N123AB

Pre-Purchase Squawk List

On-Site Pre-Buy Findings

Item #1

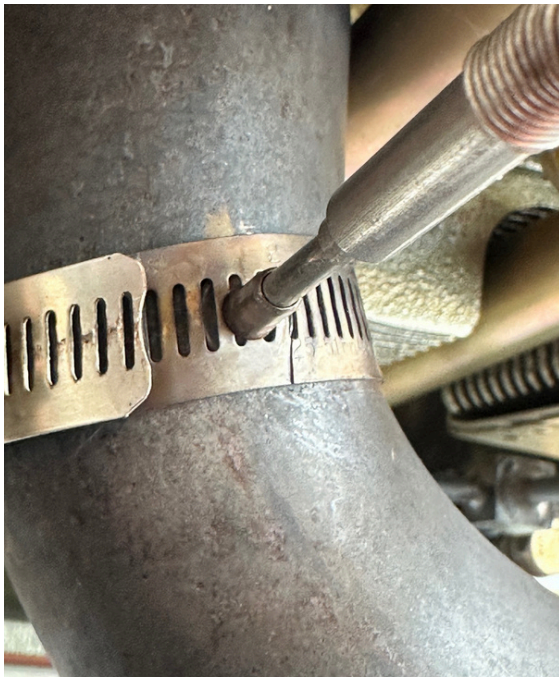
Squawks				
Item	Description	Reference	Recomendations	Estimated Correction Cost
-	<p>Engine compressions noted as follows: 1)77/80 2)72/80 3)78/80 4)77/80 5)74/80 6)76/80</p>	IO520MM	All compressions are at an acceptable level. Monitor engine health with regular compression testing and borescope inspections	-
1	All cylinders show signs of cylinder wall corrosion	IO520MM	Corrosion will most likely be removed with use, but needs to be monitored strictly	-
2	LH exhaust muffler flame cone missing. Internal baffling has disintegrated (AIRWORTHINESS ITEM)	IO520MM	Remove and replace LH muffler <u>PN:A14836-001</u>	\$800
3	Cylinder #3 EGT probe clamp has cracked near probe	IO520MM	Remove and replace probe	\$250
4	Crankshaft shows pitting between propeller flange and crankshaft/case seal. See TCM SB09-14 (AIRWORTHINESS ITEM)	IO520MM	Repair crankshaft per requirements of SB09-14	UNK
5	LH magneto data plate loose at rivets	Bendix Magneto MM	Secure mag data plate	\$100

Item #7

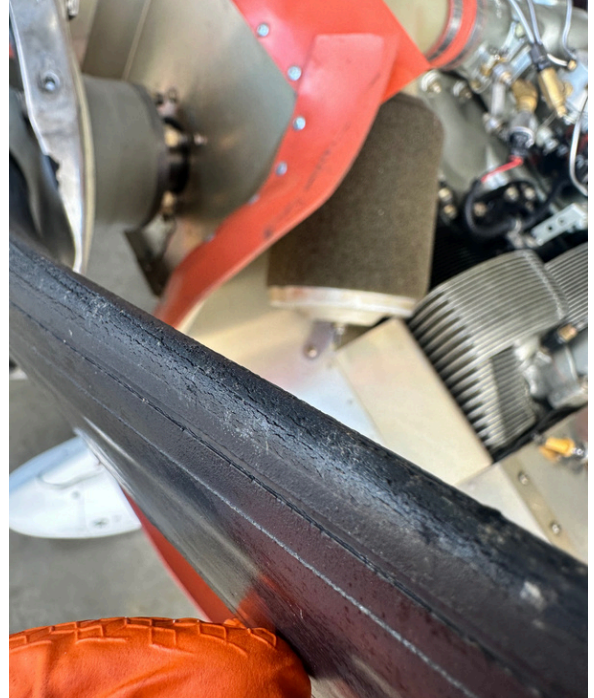
Item	Description	Reference	Reccomendations	Estimated Correction Cost
6	Popped rivet in center rubber baffling around magnetos	SR22 MM	Remove and replace rivet	\$25
7	Spinner cracked at TKS drip nozzle. Nozzles are chafing spinner. (AIRWORTHINESS ITME)	Hartzelle CS Prop MM	Dress spinner to remove cracks. Adjust TKS nozzle to prevent chafing	\$250
8	Propeller TKS boots cracking and dry-rotting	Hartzelle CS Prop MM	Apply PBS boot sealant to preserve boots. Eventually these will need to be replaced if they begin to tear	\$350
9	Battery #2 is past the 2 year replacement recommendation	SR22 MM	Remove and replace #2 batteries <u>PN:50979-001</u>	\$400
10	LH/RH wing fuel vent panels cracked near fuel vent inlet. Tygon tubing is stiff and clamps are rusting (AIRWORTHINESS ITEM)	SR22 MM	Repair/replace fuel tank vent inlets. Remove and replace tygon vent tubing and clamps	\$450

Item #11

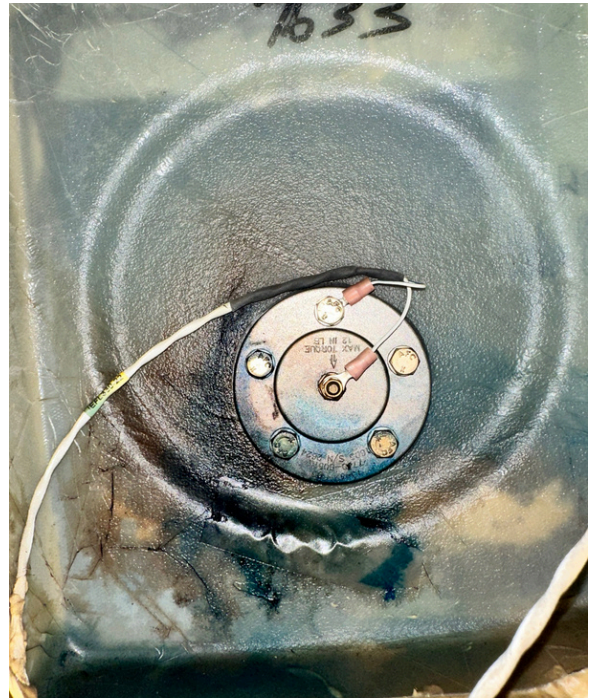
Item	Description	Reference	Reccomendations	Estimated Correction Cost
11	LH wing, inboard fuel sending unit leaking at base gasket (AIRWORTHINESS ITEM)	SR22 MM	De-fuel tank. Remove and replace base gasket, complete a leak check	\$350
12	Popped rivet noted in RH wing, inboard TKS panel (AIRWORTHINESS ITEM)	SR22 MM	Install new rivet as required	\$100
13	Upper fueslage antenna seals dry and deteriorating	SR22 MM	Reseal bases of antennas	\$350
14	Main cabin door foam seals deteriorating	SR22 MM	Remove and replace seals	\$350
15	Ignition switch loose in panel (AIRWORTHINESS ITEM)	SB2X-74-02	Comply with Cirrus SB2X-74-02	\$150
